PLANNING REPORT

Architectural Review Board

20 North Street Case 25-118MPR

25-118MPR - 20 North Street Renovations

South Elevation Previously-Approved

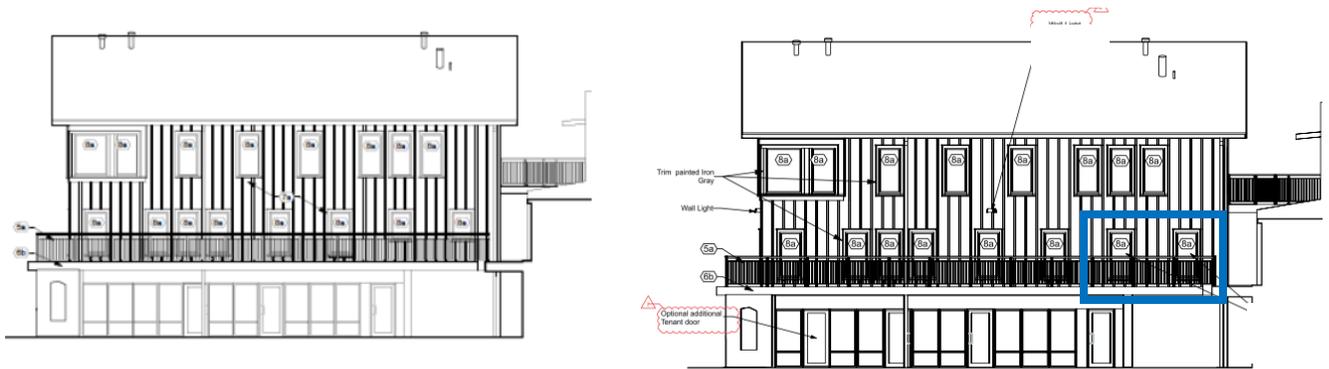
This request seeks to modify the previously-approved central window arrangement to accommodate a re-oriented internal stair. The new stair arrangement makes good sense from a usability standpoint; however, it would create some oddities with the previously-approved windows if they were left unchanged. The requested window is an enlarged double-hung window form that spans the two floors, as shown below. The window will measure 11'-3" x 4'-4". After careful thought and comparison with the Guidelines and the intent of Background buildings, staff has determined that this approach has an appropriate sense of charming whimsy. It will create activity on the street by making the central stairwell visible and lit from inside. Staff supports the new window arrangement as it replicates an over-sized, but very traditional, form in the District.

This request also seeks to put in a new door where a window was previously-approved. The requested door is located on the eastern end of the ground floor of the building. This request aims to create an “improved environment for walking.” The entry uses a standard punched opening with an attached sidelight. The door will be 7’-6” x 3’ with the sidelight being 2’-2” in width. A sign will be attached to the stone above (separate approval via Case 25-121). Staff supports this addition for a greater street presence at the lower level.

These requests align with the goal in the previous MPR to modify the character of previous “modern” additions to be more appropriate to the District function. These requests also align with the original goal of enhancing streetscape interaction opportunities. For these reasons and the reasons listed above, Staff supports all requests on this elevation.
